Access Compliance Report

Public Rights-of-Way

Intersection ID: 47659	Main Street: FENWAY_DR	Cross Street: WRIGLEY_DR	Location: SW
ADA ID: C3D0D4D50F93	Ramp Type: PerpDiag	Initial Pass/Fail: Fail	Overall Compliance: No
Severity Score: 10			
Codes/Mitigation Info/Possible Solution		Field Measurements/Component Compliance

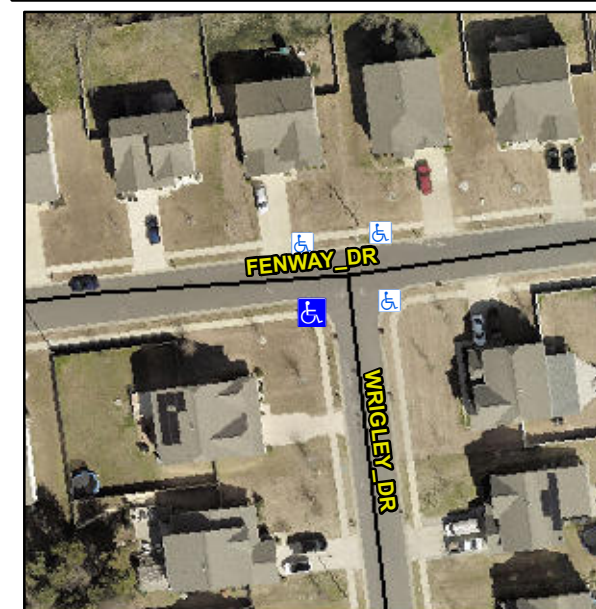
Not Found, R304.5.1, R304.5.3

Compliance	Description	Data	Compliance	Description	Data
N/A	Ramp Length (in)	48.0	Yes	Ramp Slope (%)	6.0
No	Ramp Width (in)	46.0	No	Ramp XSlope (%)	2.3
N/A	Flare Type LT	N/A	N/A	Flare Type RT	N/A
N/A	Flare Slope LT (%)	N/A	N/A	Flare Slope RT (%)	N/A
N/A	Flare Traversable LT?	N/A	N/A	Flare Traversable RT?	N/A
N/A	Landing Length (in)	N/A	N/A	DWS Provided?	N/A
N/A	Landing Width (in)	N/A	N/A	DWS Contrast?	N/A
N/A	Landing Slope (%)	N/A	N/A	DWS Length (in)	N/A
N/A	Landing X Slope (%)	N/A	N/A	DWS Full Width?	N/A
N/A	Landing Curb? (Y/N)	N/A	N/A	DWS Offset (in)	N/A
N/A	Shared Landing?	N/A			
N/A	Gutter Ponding?	N/A	N/A	Gutter Slope (%)	N/A
N/A	Gutter Lip Ht (in)	N/A	N/A	Gutter X Slope (%)	N/A
N/A	Painted X Walk1?	No	N/A	Painted X Walk2?	No
	X Walk 1 Direction	To E		X Walk 2 Direction	To N
N/A	X Walk 1 Width (in)	N/A	N/A	X Walk 2 Width (in)	N/A
	X Walk 1 Slope (%)	6.3		X Walk 2 Slope (%)	1.4
	X Walk 1 X Slope (%)	0.6		X Walk 2 X Slope (%)	3.7

N/A	Ramp inside XWalk1?	N/A	N/A	Ramp inside XWalk2?	N/A
	Road Slope (%)	2.9	N/A	Clear Space?	N/A
	Road X Slope (%)	4.2	N/A	Clear Space to XWalk (in)	N/A
N/A	Any Obstructions?	N/A	N/A	Storm Grate/Utility Hazard?	N/A
	Obstruction Type			Storm Grate/Utility Type	
		N/A			N/A
		Yes		Surface Condition? (G/P)	Good

Remove & Replace Curb Ramp With Two New Directional Ramps or Equivalent.
